Staff Cubicles Specs (or non-specs) Inbox x Library x

Dwight Duensing
IT Manager
St. Bernard Parish Library

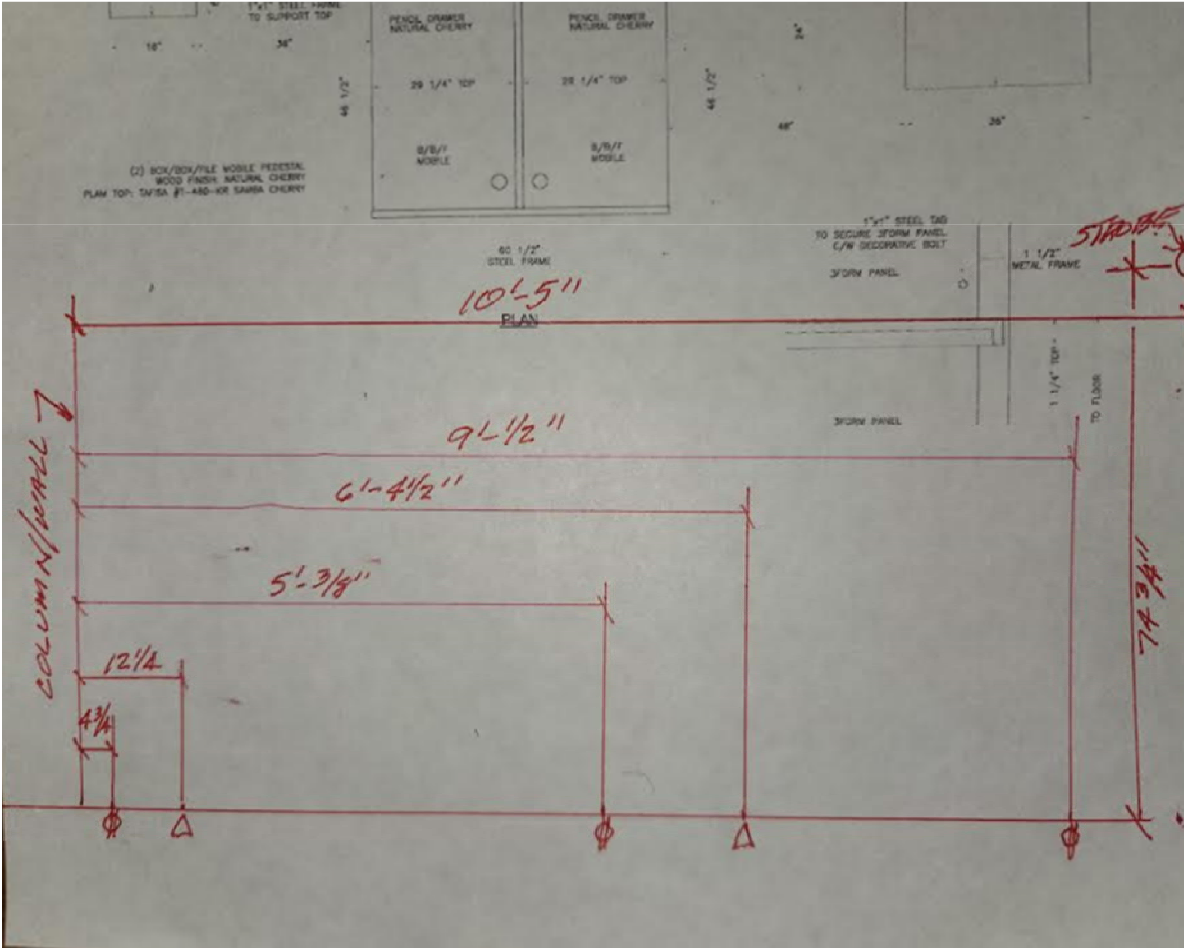
As requested the attached are the dimensions. See if this will work for you. Call with questions.

Thank you for the measurements. From the photo I took on August 27th, Lanny's distances do match what I can see.

Actual outlet measurements overlaid on cubicle layout

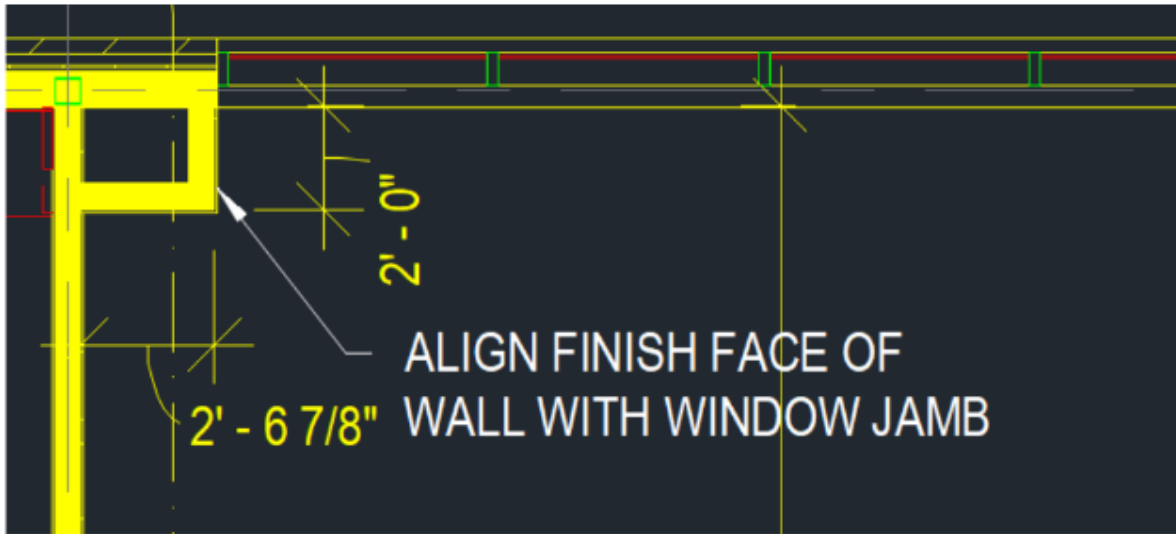
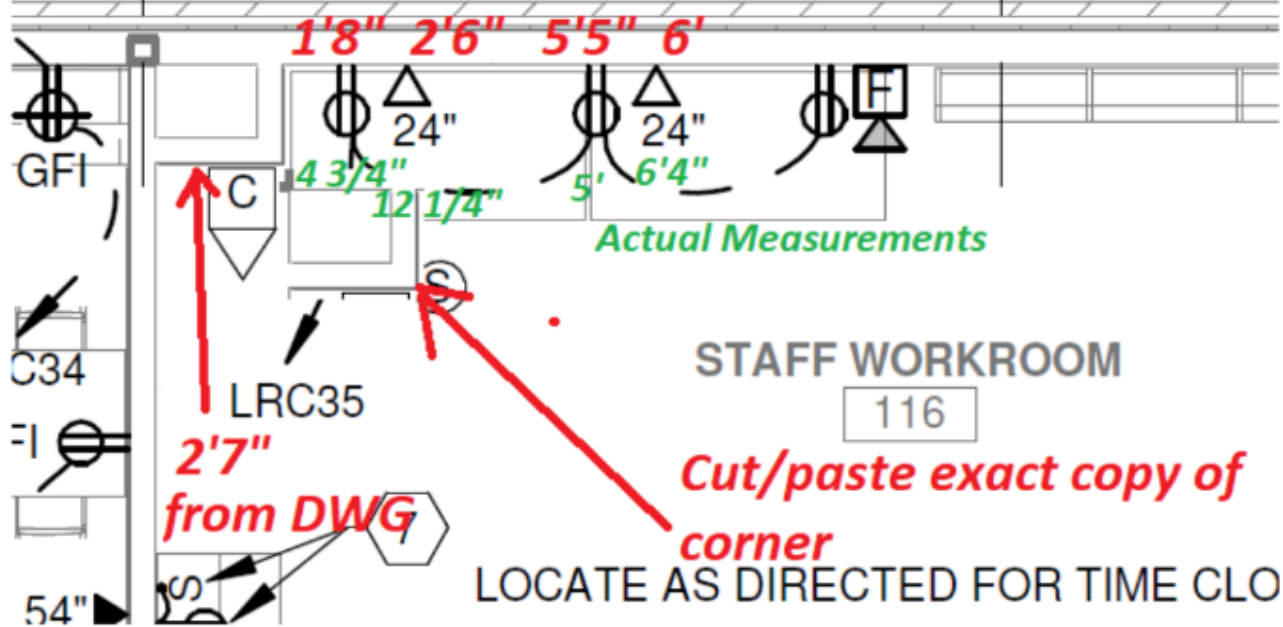
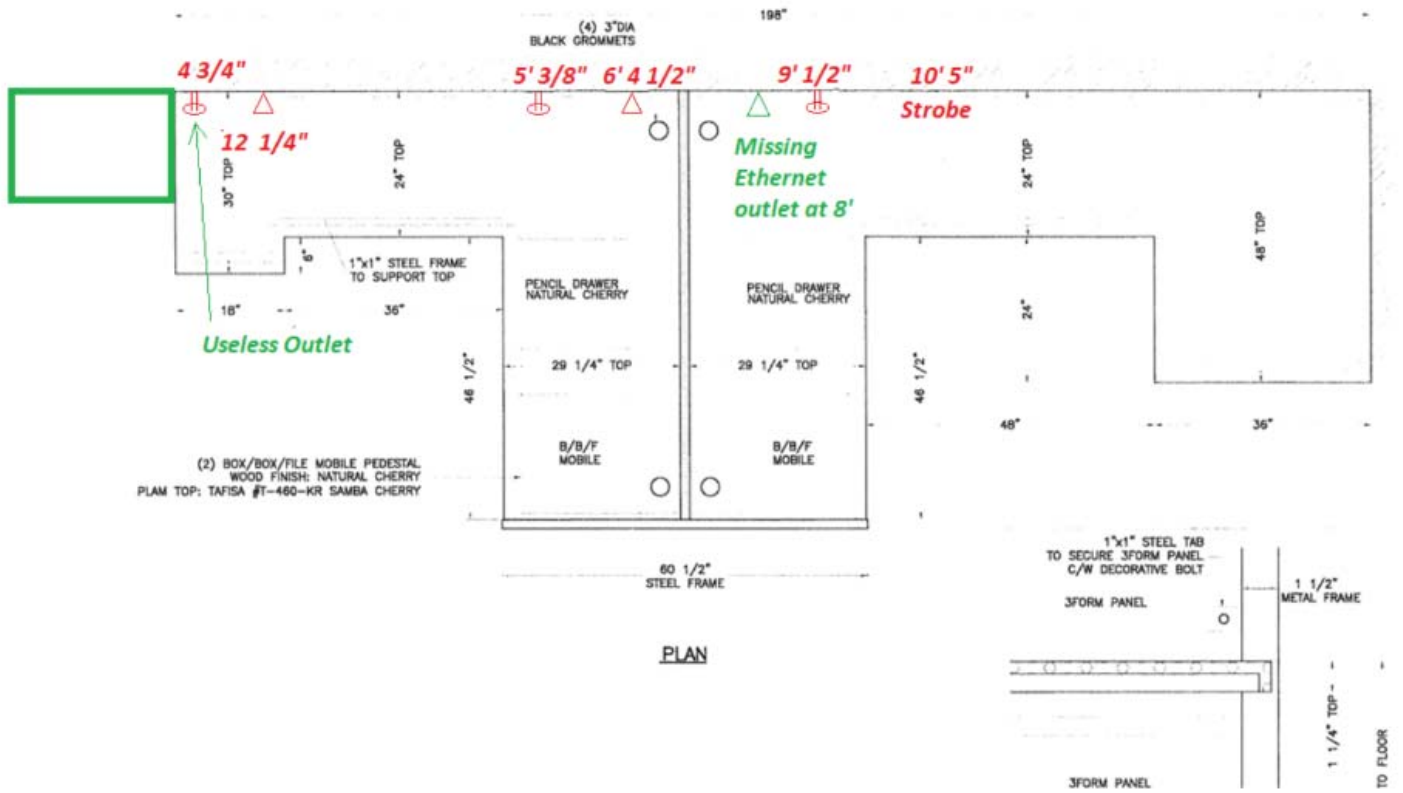
I am confused about the actual distances versus what was in the architect electrical drawings. Using the one DWG file and the electrical PDF architect file, it seems that the distances are off by at least 16 inches near the corner and about 6 inches near where the double cubicles end. Is this because the electricians needed to be near a stud to put the outlets? Or is there another reason why they deviated the plan? (See document attached)

Per your question about outlet/ethernet placement with the new cubicle layout, I have overlaid Lanny's measurements onto the layout to see where they are located (see last page of attachment). The two electrical outlets are fine, but we have a problem with the dual ethernet jack for the right cubicle.

This can be forced (or "kludged") to work by running the phone/data wires nearest the cubicle mating "under" the center support, and by extending the leftmost phone/data wires an additional 7 feet in a "L raceway" under the countertop. Would this violate any electrical codes? For a new building, this is NOT an ideal solution.

While the staff rarely uses the cabinet lighting in the cubicles, there is also the problem of placing the switch and the outlet above the cabinets to power the cabinet lights.

The library would prefer that drywall be removed to facilitate the fixes.
